AMENDMENT OF SOLICITATION/MODIFICATION OF CONTRACT

0009

LAKE OKEECHOBEE WATER RETENTION/PHOSPHOURUS REMOVAL PROJECT, TAYLOR CREEK, GRASSY ISLAND STORM WATER TREATMENT AREAS, OKEECHOBEE COUNTY, FLORIDA

LAKE OKEECHOBEE WATER RETENTION/
PHOSPHORUS REMOVAL PROJECT
TAYLOR CREEK - GRASSY ISLAND
STORMWATER TREATMENT AREAS
CIVIL
BOAT RAMP/CROSSOVER DETAIL

DRAWING NO.
C115

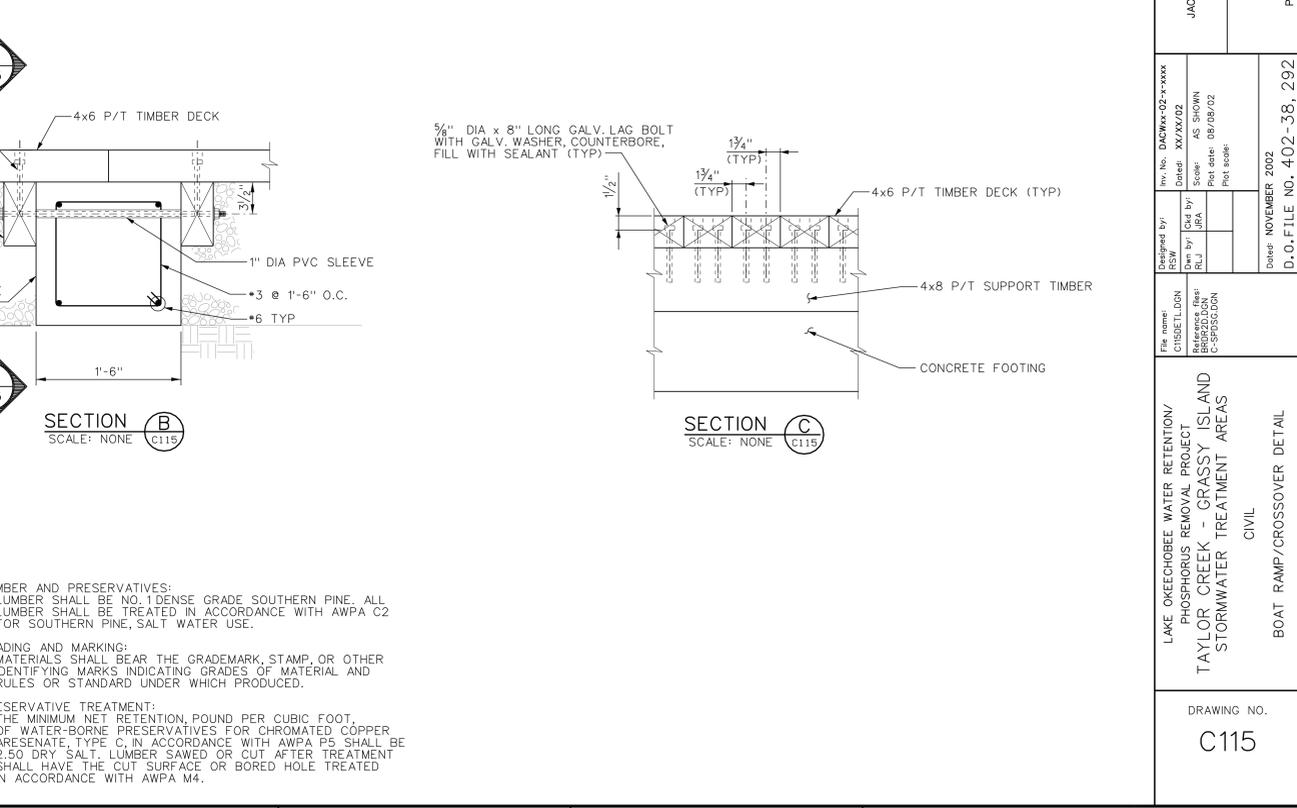
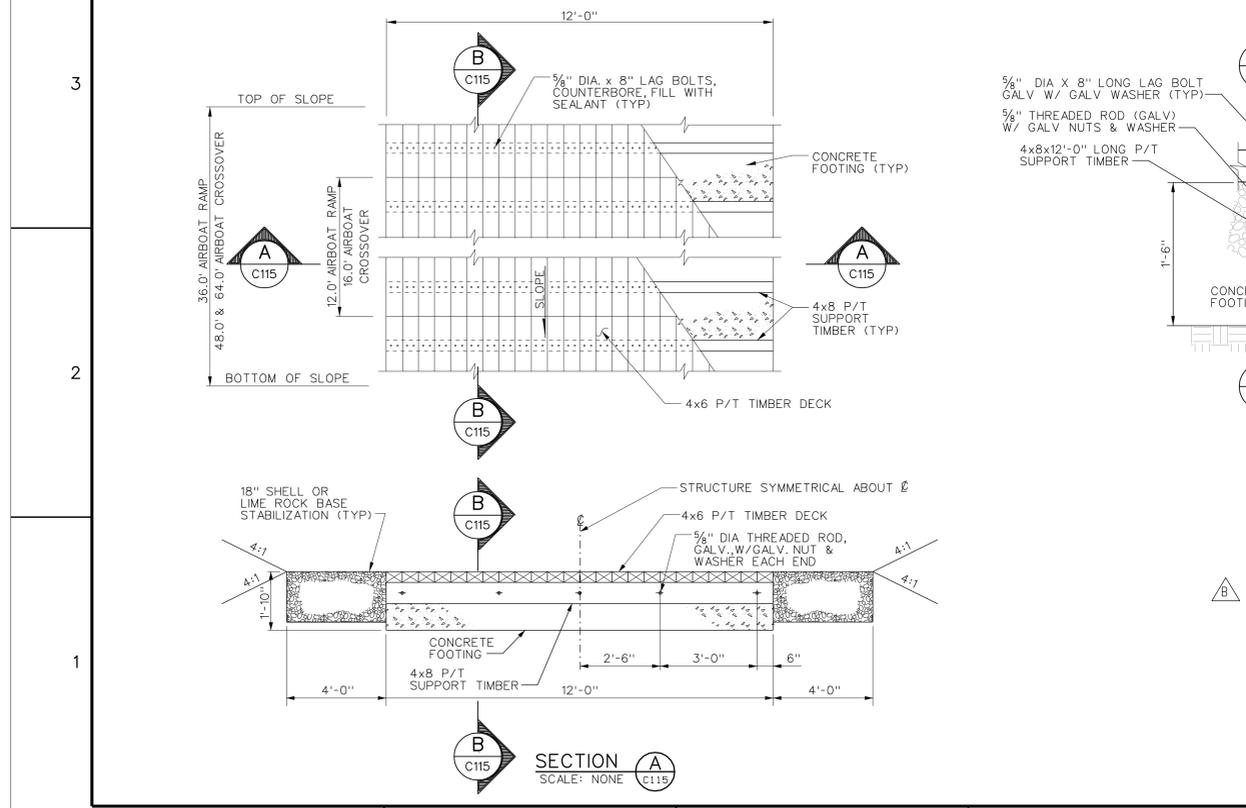
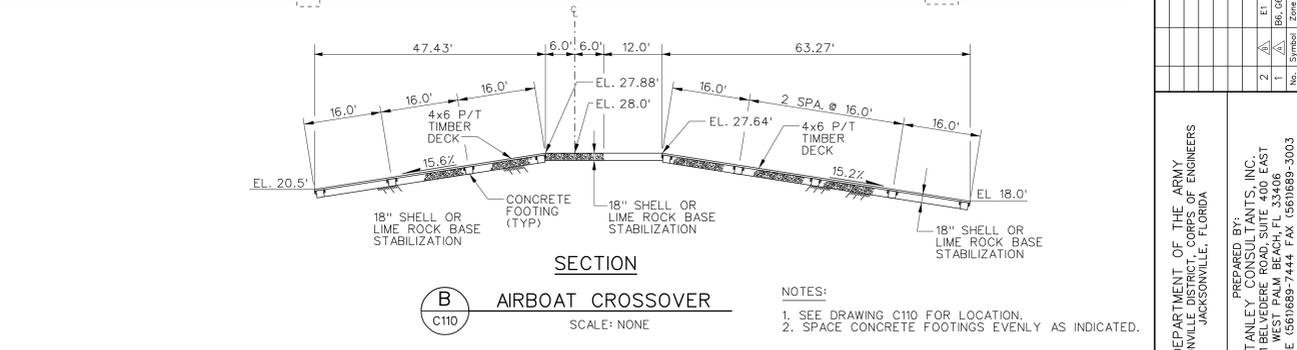
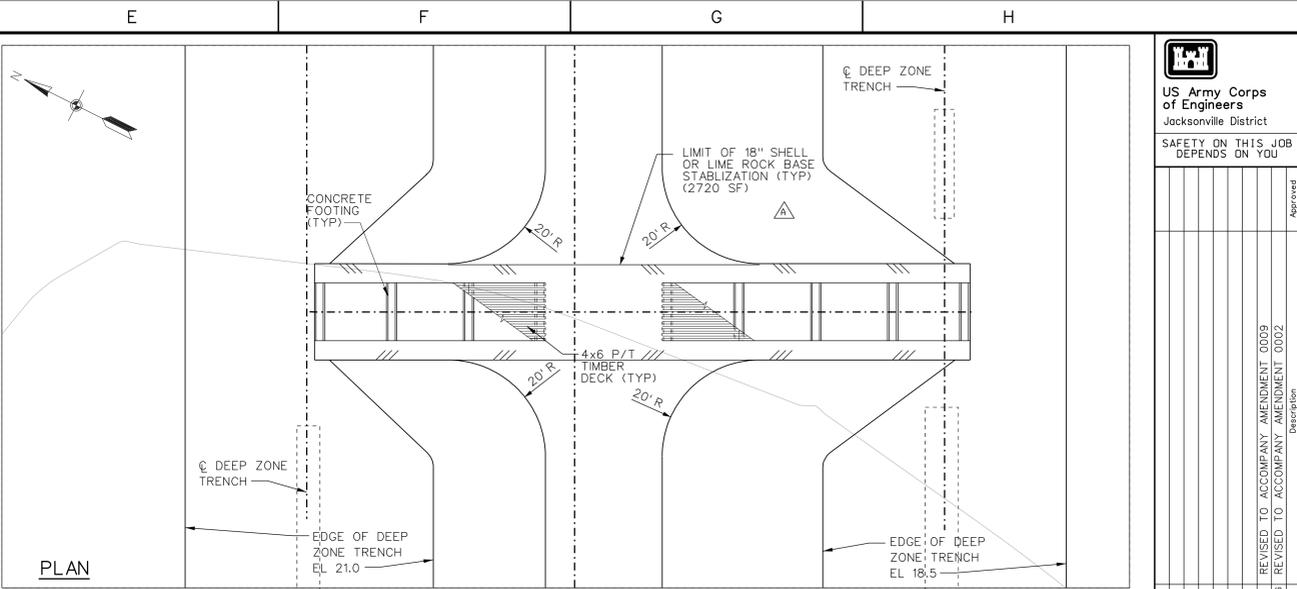
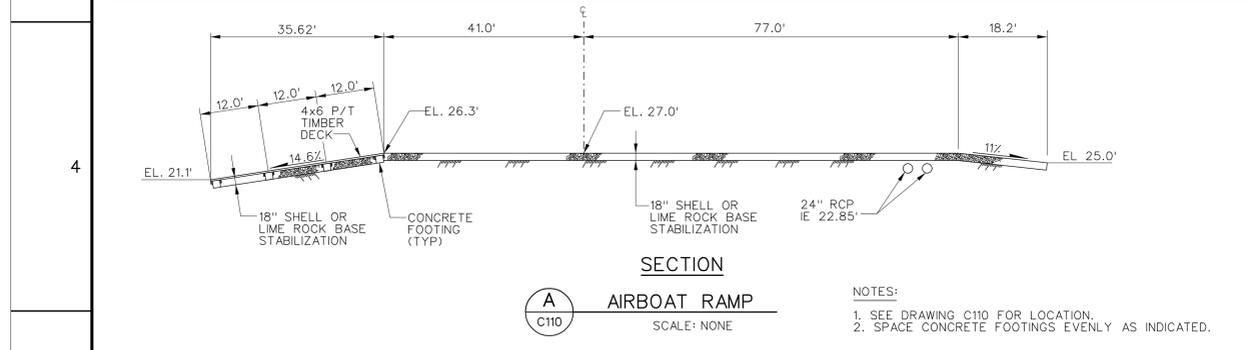
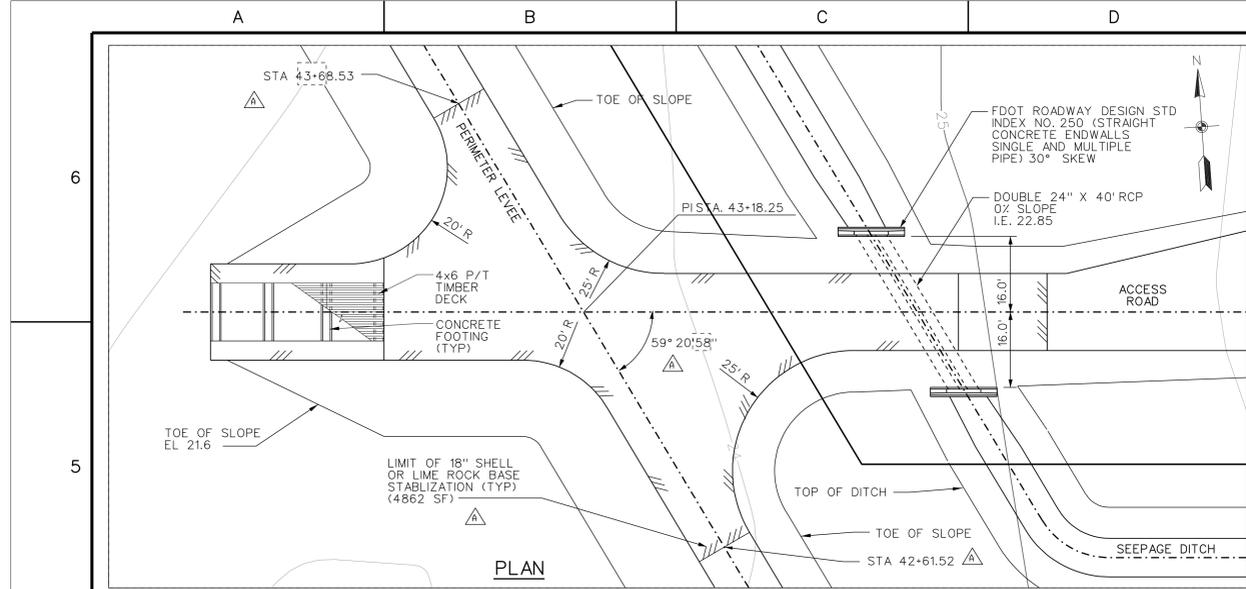
Delete drawing C-115 and and replace with the revised drawing C-115:

LUMBER AND PRESERVATIVES:
LUMBER SHALL BE NO. 1 DENSE GRADE SOUTHERN PINE. ALL LUMBER SHALL BE TREATED IN ACCORDANCE WITH AWPA P5 FOR SOUTHERN PINE, SALT WATER USE.

GRADING AND MARKING:
MATERIALS SHALL BEAR THE GRADEMARK, STAMP, OR OTHER IDENTIFYING MARKS INDICATING GRADES OF MATERIAL AND RULES OR STANDARD UNDER WHICH PRODUCED.

PRESERVATIVE TREATMENT:
THE MINIMUM NET RETENTION, POUND PER CUBIC FOOT, OF WATER-BORNE PRESERVATIVES FOR CHROMIATED COPPER ARSENATE, TYPE C, IN ACCORDANCE WITH AWPA P5 SHALL BE 2.50 DRY SALT. LUMBER SAWED OR CUT AFTER TREATMENT SHALL HAVE THE CUT SURFACE OR BORED HOLE TREATED IN ACCORDANCE WITH AWPA M4.
